**COMMUNITY DEVELOPMENT
DEPARTMENT REPORT**

HEARING DATE: 7/14/2026
 TO: Mayor & City Council
 FROM: Sonya Allen, Associate Planner
 208-884-5533
 sallen@meridiancity.org
 APPLICANT: Travis Butterfield, McCarter-Moorhouse
 SUBJECT: SHP-2026-0006
 Treviso Subdivision

A. Short Plat (date: 4/16/2026)

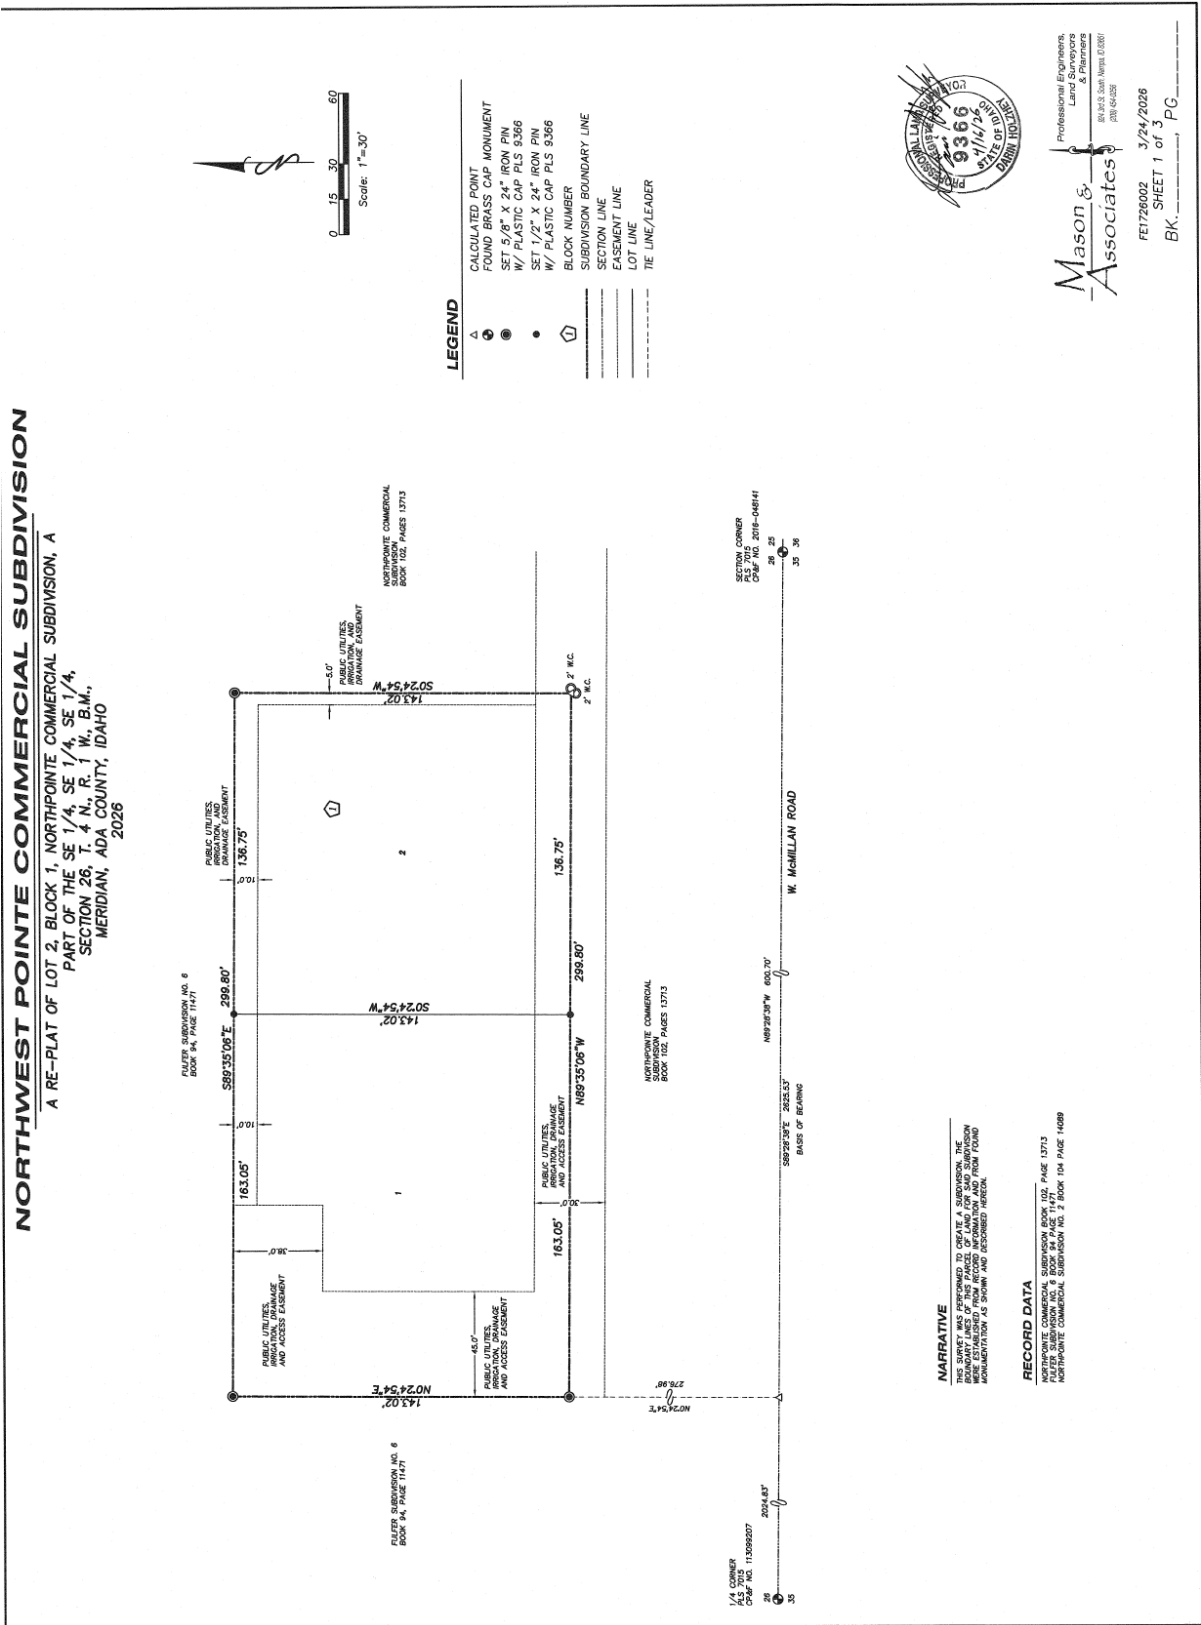
A cross-access easement is graphically depicted on the proposed plat along the west and south boundary of Lots 1 and 2, Block 1 for access between the proposed lots and those to the south and east. **A note should be included on the plat stating a cross-access/ingress-egress easement is provided to the property to the east at 4895 N. Linder Rd. and to the south at 1750 W. McMillan Rd.**

- a. A note shall be included on the plat stating a cross-access/ingress-egress easement is provided to the property to the east at 4895 N. Linder Rd. and to the south at 1750 W. McMillan Rd.
